Wyckham Park Residents' Association (WPRA)

Case No. 313220

Description: SHD Development of Demolition of all existing buildings on site, construction of 881 no. apartments, creche and associated site works.

Address: Old Dundrum Shopping Centre known as Old Dundrum Village Centre and Adjacent properties to the west of Main Street, Dundrum, Dublin 14

Quality of Residential Amenity of the Scheme:

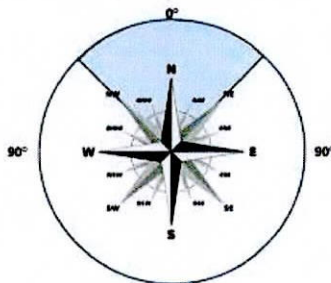
- The entrance doorways and entrances into the blocks are dark, unwelcoming and would have a feeling of poor security. The entrance into Block A, the 16 storey tower block, is north-facing, narrow, recessed and overall poorly designed. For the landmark, standout building this is meant to be this is a mean entrance with a shockingly poor entrance into the scheme.

- Long corridors, particularly in Block 1A with no natural light or ventilation in any of the corridors in any of the blocks
- The floor areas do not comply in terms of widths of rooms
- Balconies and residential units have wholly unsatisfactory relationships with one another with windows of one unit looking directly into the balcony of an adjoining unit as a result of the applicant's efforts to achieve dual aspect
- Communal and public amenity spaces are overshadowed
- Amenity spaces for residents have not been thought through with unspecified uses given throughout the drawings
